ADDENDUM NO. 2

DATE: September 16, 2016

Contract 15-C-00059; Upper Peninsula Stormwater Improvements Phase 2 (Vasconia Outfall) – Rebid

SHEET
11
 of
 105

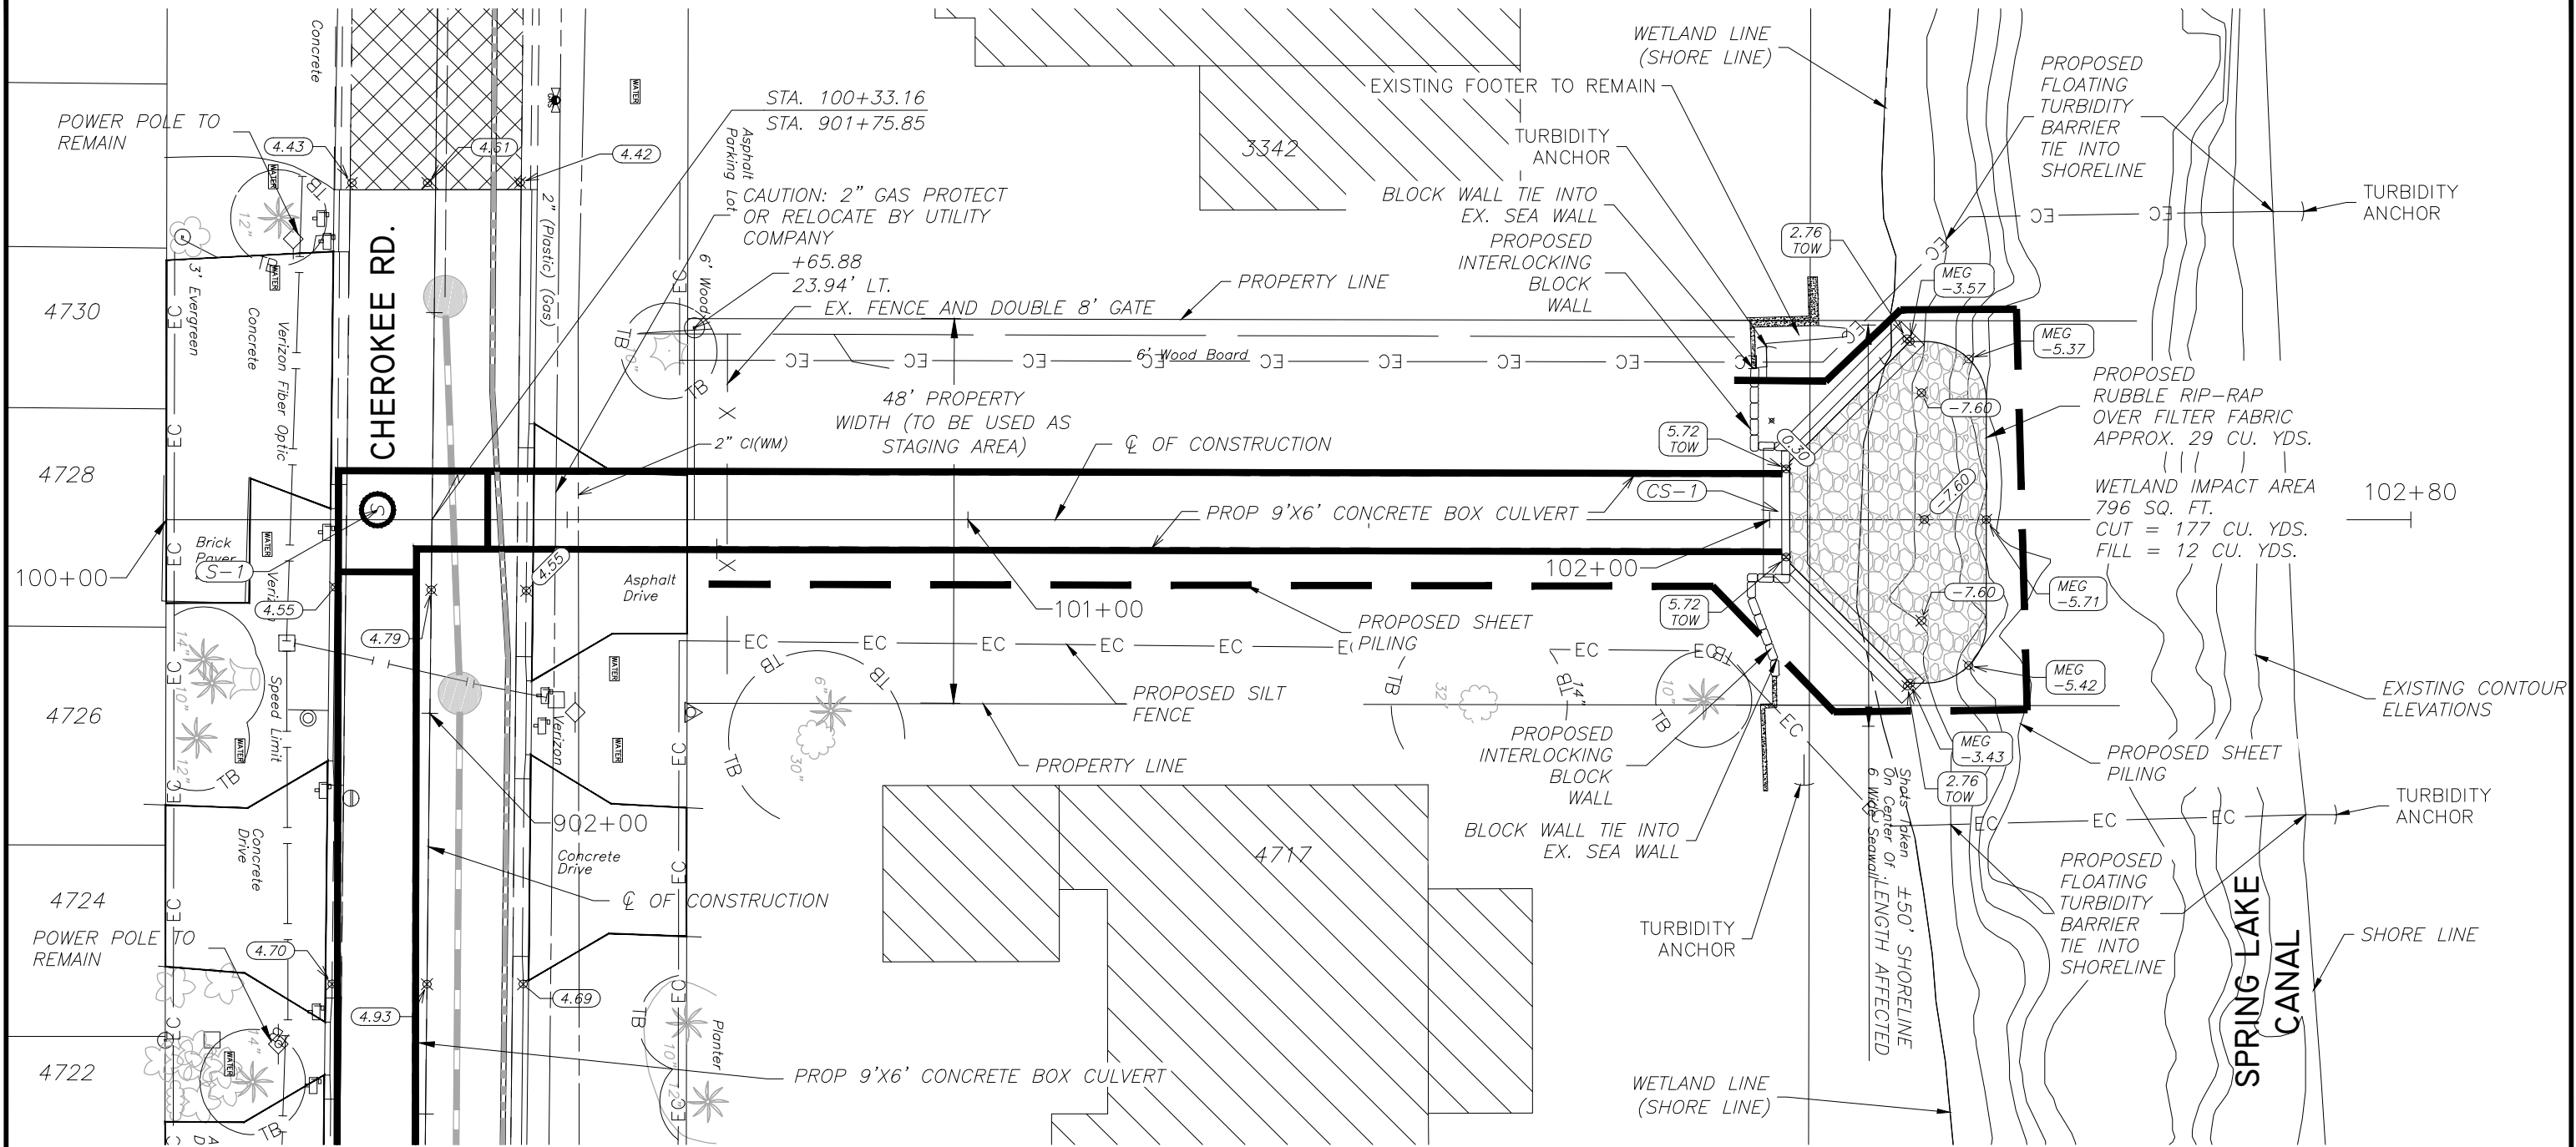
- Item 7: Replace plan sheet nos. 11 and WW112 with the attached plan sheet nos. 11 and WW112.

(S-1)
 STA. 901+74.69, 6.81' RT.
 PROP CUSTOM J-BOX/CONFLICT STRUCTURE W/MH RISER
 INV EL: 9'X6' CONCRETE BOX CULVERT (E) = -7.00
 INV EL: 9'X6' CONCRETE BOX CULVERT (N) = -7.04
 TOP SLAB EL: -0.291
 MH RISER RIM: 4.62
 SEE STRUCTURE DETAILS SHEET
 FOR SIZING AND MORE INFORMATION

(CS-1)
 STA. 102+01.52, 0.89' LT.
 PROPOSED WINGWALL PER FDOT INDEX 289
 INV EL: 9'X6' CONCRETE BOX CULVERT (S) = -7.20
 NO MANATEE GRATE REQUIRED FOR 9X6 OUTFALL
